**IN THE DISTRICT COURT OF TETON COUNTY, WYOMING
NINTH JUDICIAL DISTRICT**

**PETITION FOR REVIEW OF AGENCY ACTION AND
REQUEST FOR STAY UNDER RULE 12.05**

The following comments are submitted on behalf of Protect Our Water Jackson Hole (POWJH) in response to the DEQ's October 28, 2022, request for comments on the above-referenced NOTIFICATION OF COVERAGE published on the DEQ's Water & Wastewater webpage under "Recent General Permit Authorizations."

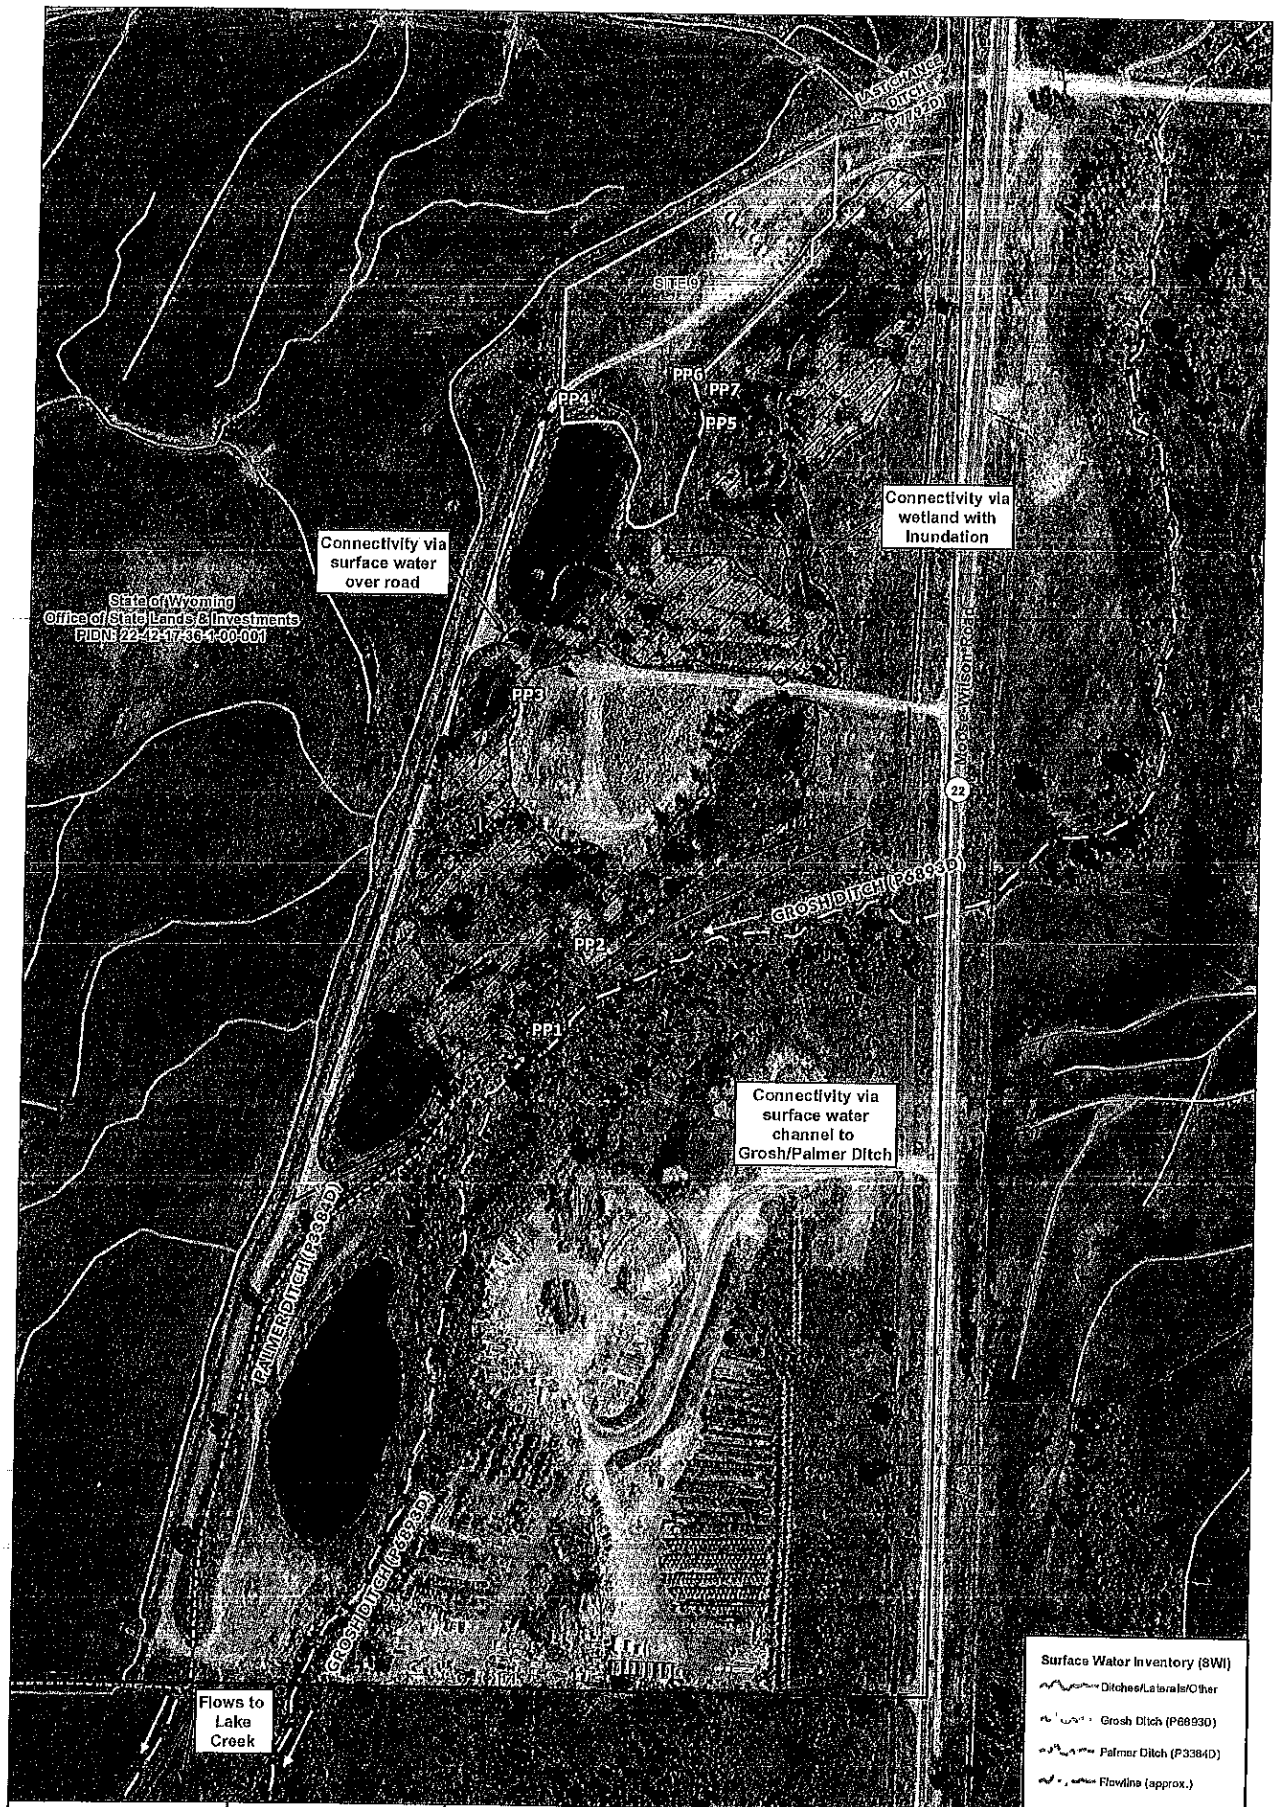
The proposed development plans at Site 9 (Teton Village Resort Construction Plans, 11/9/22) depicts a leachfield and mound near and likely within potential wetlands and surface waters. The existing contours on the plan set, a review of aerial imagery, and site observations indicate the mound from the leachfield extends into the wetland/pond complex. The leachfield infiltrators are less than 50 feet from estimated wetlands and possibly surface waters.

C-102

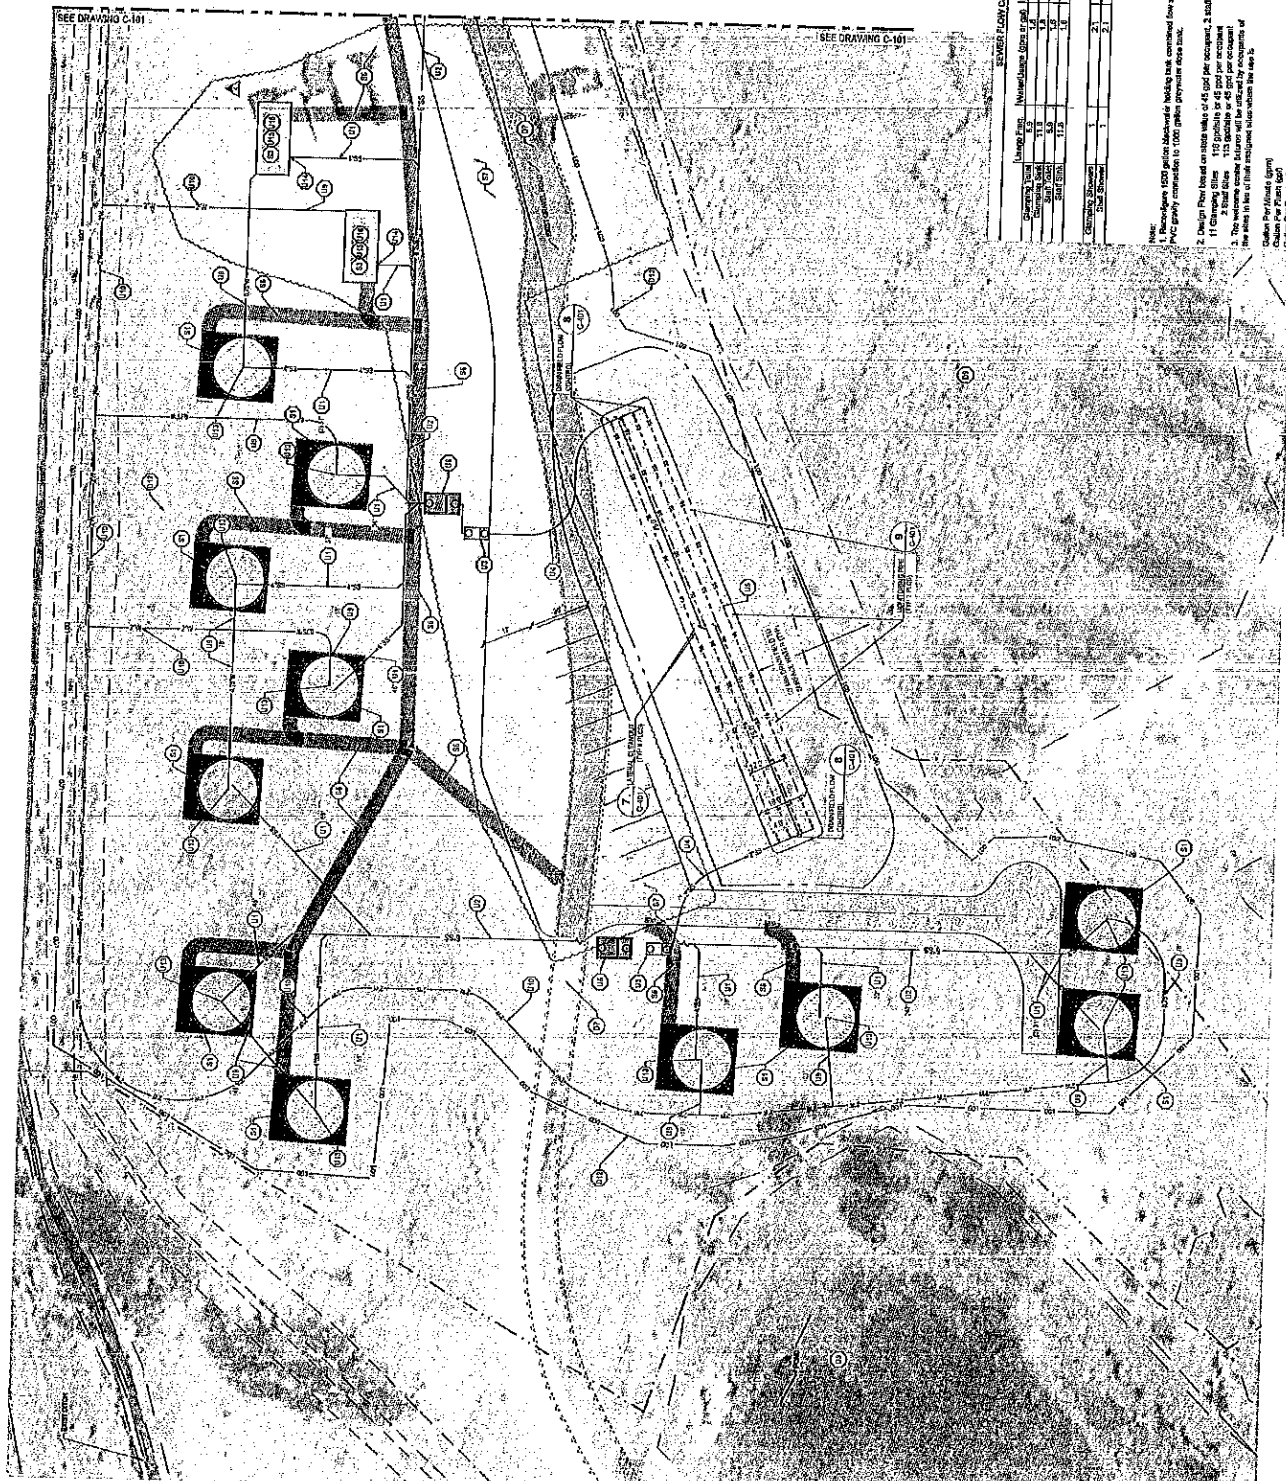
- The sewer flow calculations (Sheet C-102 of Teton Village Resort plans dated 11/9/22) are now based on a rate of 2.6 occupants per glamping unit and 2.5 occupants per staff (employee) unit, for a daily occupancy average of 33.6. See additional discussion of wastewater calculation elsewhere in this report.

Based on the Sewer Flow calculation on sheet C-102, the engineer has utilized a flow rate of 45 gallons per day (gpd) for the Teton Village Resort. This design flow rate is from WDEQ, Water Quality, Chapter 25, Section 4, Table 2 (Non-Residential Wastewater Design Flow Rates) for a "Campground with shower facility" designation. In WDEQ, Water Quality, Chapter 11, Section 4, Definitions:
